RotorSport UK Ltd Service Bulletin (Permit)

Title: MTOsport 2017 mast drain hole		Release date 17.06.2019
SB-133 Iss1	Related documents Modification: CCAR No.: None	Compliance Category: OPTIONAL or RECOMMENDED or MANDATORY
Applicability		
Aircraft type & model: MTOsport 2017	Aircraft serial Nos. affected: Serial 001 to 011	
The maintenance manual to be referenced is this stated or subsequent issue.		RSUK0395 Iss 1
<p>This form is the response from RotorSport UK Ltd either against a problem found in the product in service requiring a containment or rectification action, or as service information for aircraft modification incorporation. For help, contact RotorSport on 44(0)1588 505060, or email compliance@rotorsport.org.</p> <p>The technical content of this document is approved under the authority of the UK CAA Design Organisation Approval Ref: DAI/9917/06</p>

Title: Check For Presence Of Mast Root Drain Hole		
AG-SB-2019-01-A-EN		Compliance Category:
Applicability		A - MANDATORY B - RECOMMENDED C - OPTIONAL
Aircraft type & model: MTO2017	Affected Serial number(s): All MTO2017 models	
The maintenance manual to be referenced is this stated or subsequent issue.		As per AutoGyro websi

Fig. 1

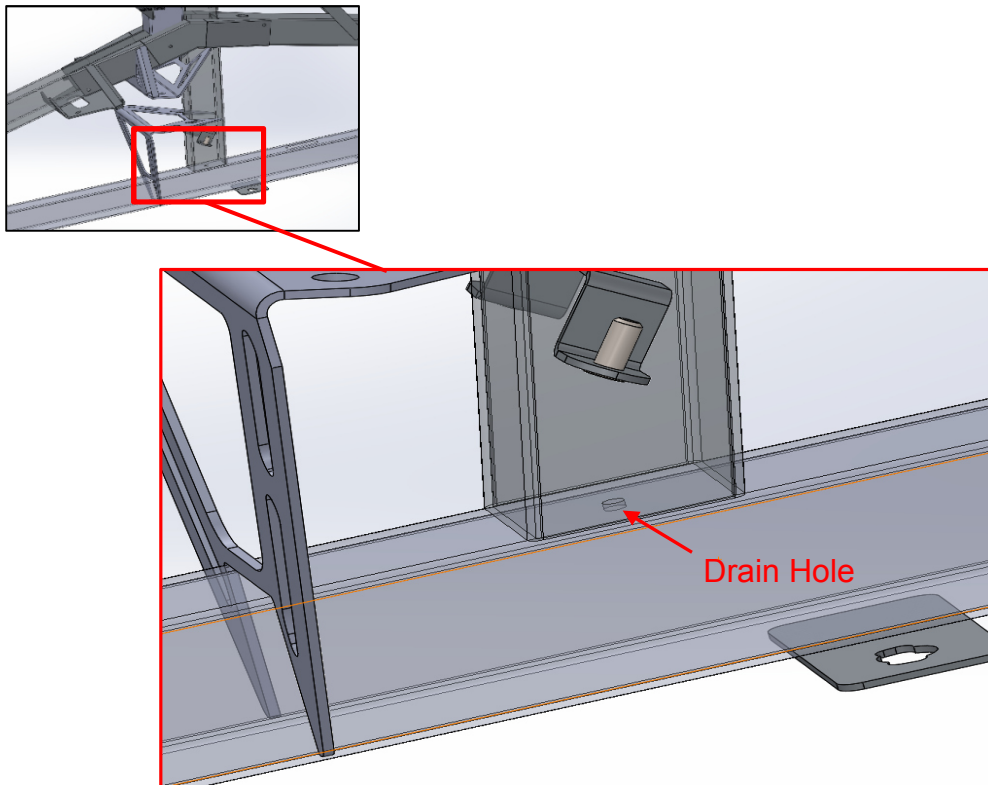
It has been found that during production of the main frame, the main mast root drain hole (fig 1) may have been left out of the frame assembly on a small number of MTO2017 frames currently in the market.

Fig. 4

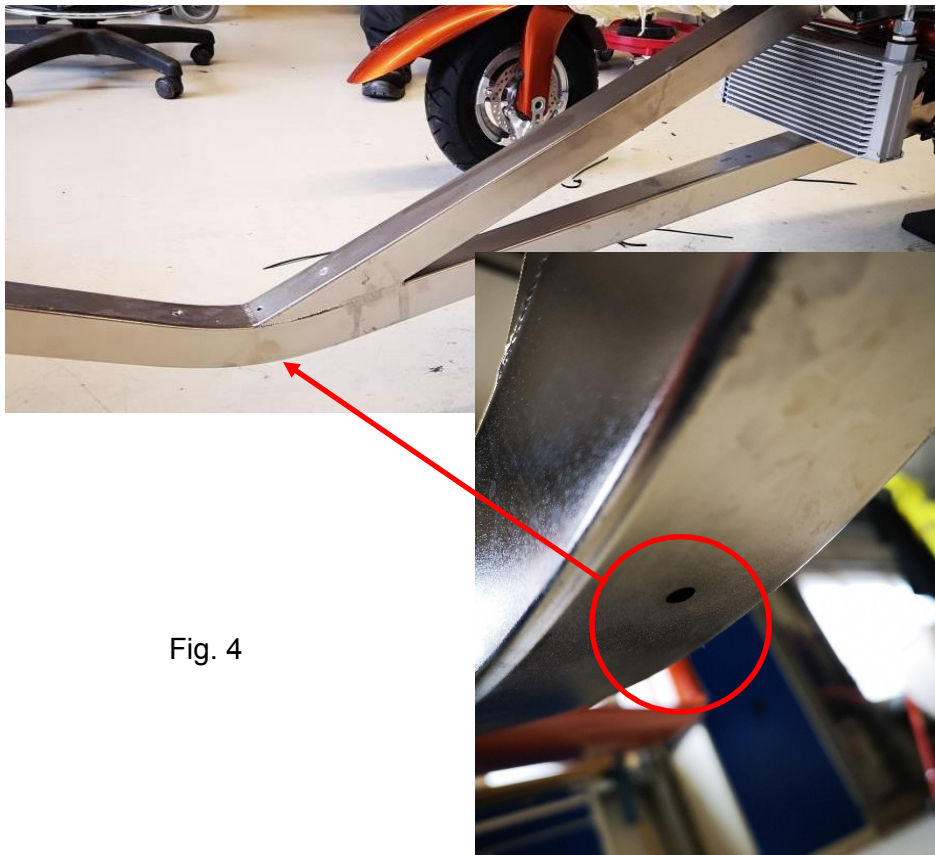
- e. If distilled water is observed emanating from the rear keel tube lower drain hole (fig 4) then the mast drain hole is present. No further action is required. Re-assemble the side & mast fairings.

Fig. 5

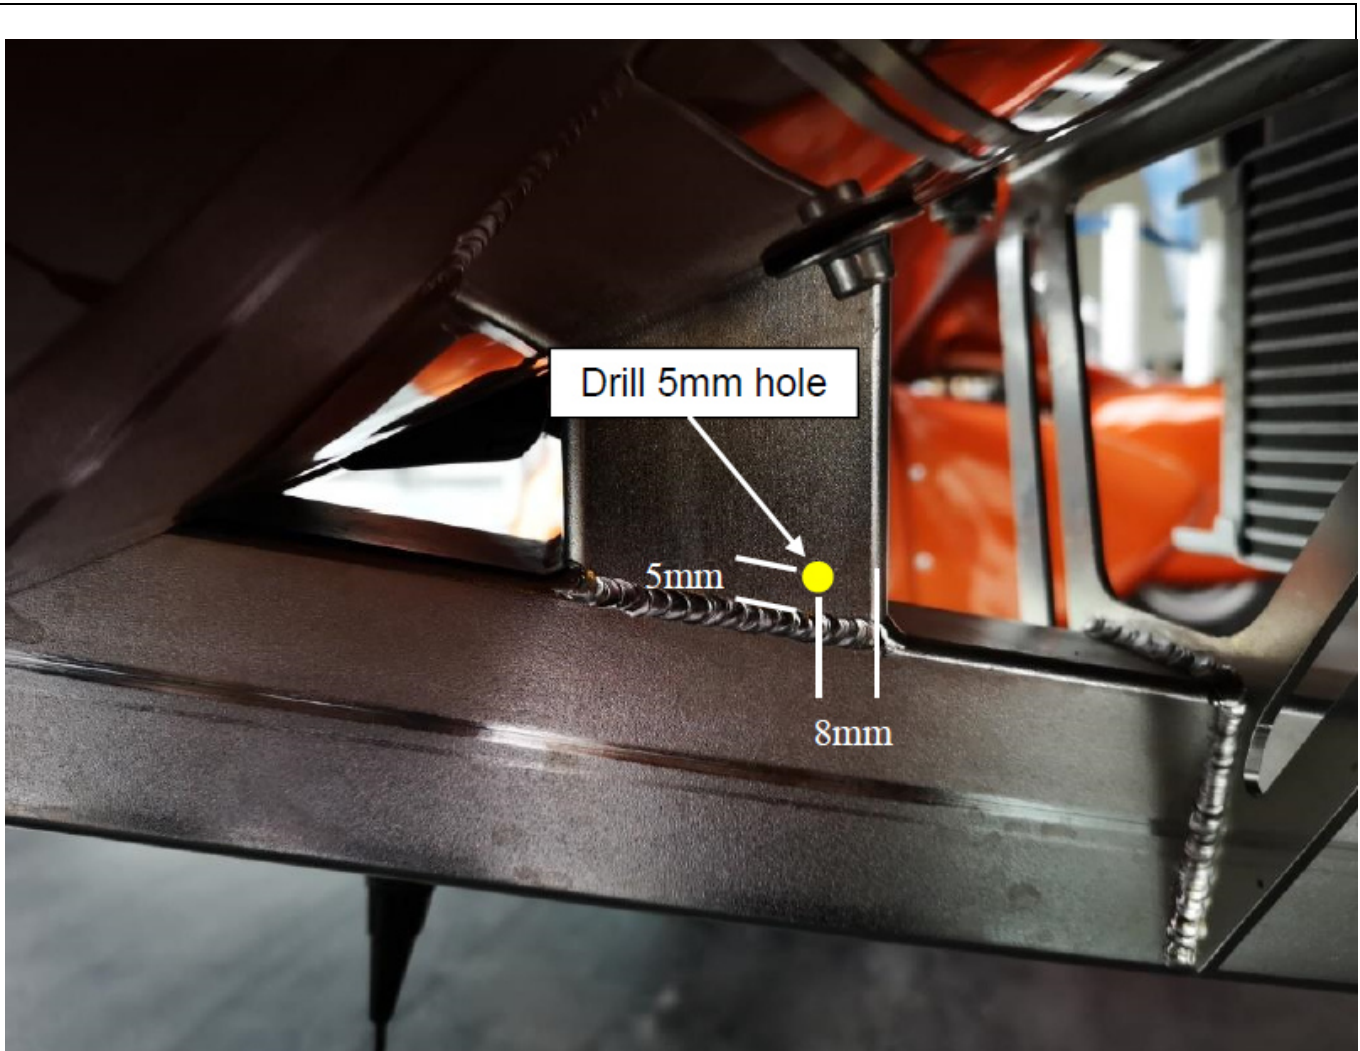
4. Centre-punch, then drill a 5mm hole on the left rear side of the mast root 5mm above the weld, 8mm forward of the rear vertical curved edge (fig 5) and allow any trapped fluid to fully drain.
